**Environmental Defense Institute**  
**Troy, Idaho 83871-0220**

**November 3, 2006**

**RE: Preliminary Comments on Department of Energy Class 3 Draft Modified Permit to the Volume 14 for the Idaho Nuclear Technology and Engineering Center (INTEC) at the Idaho National Laboratory, Permit Number EPA ID No. ID4890008952I INTEC Liquid Waste Management System and the Integrated Waste Treatment Unit**

**FIGURE 2-4.**  
Current INTEC high-level waste system  
simplified flow diagram.

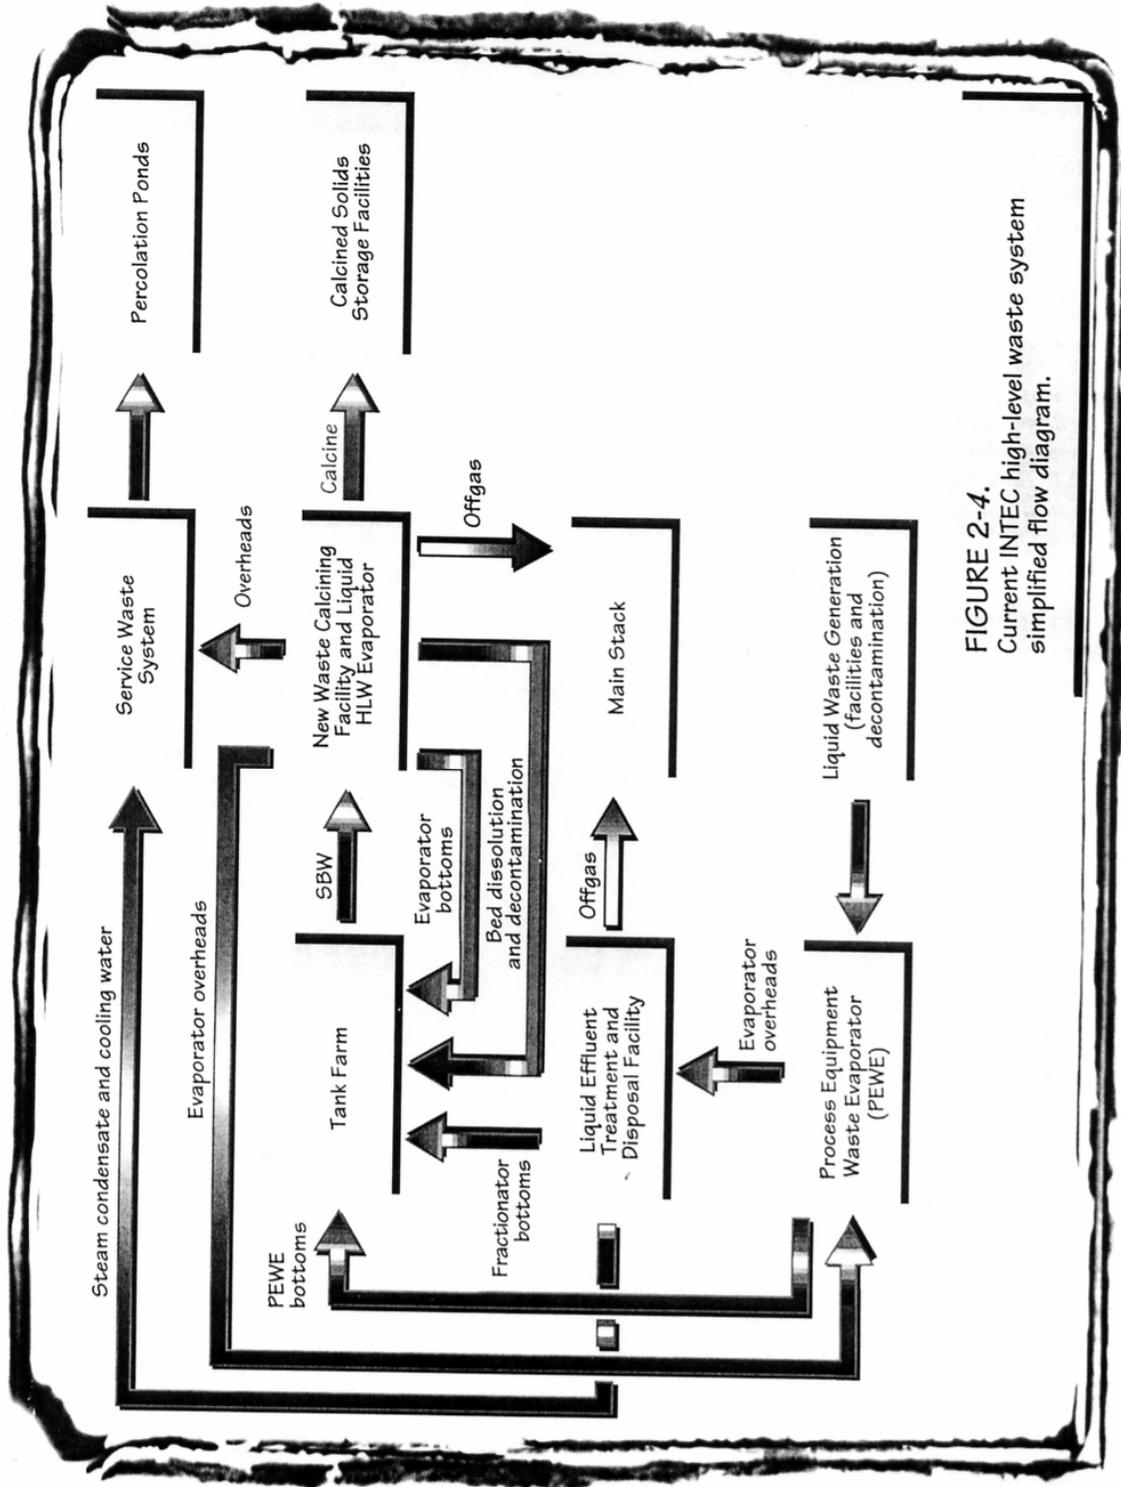
The DOE HLW &FD EIS (DOE/EIS-0287D) page 1-13 (Figure 1-6) and DOE/EIS-0287 Final page 2-11 (figure 2-4) clearly shows the High-level Liquid Waste Evaporator also housed in the New Waste Calciner building, and now called the ETS, emissions go directly to the INTEC main stack. <sup>45</sup> See Attachment C Schematic.
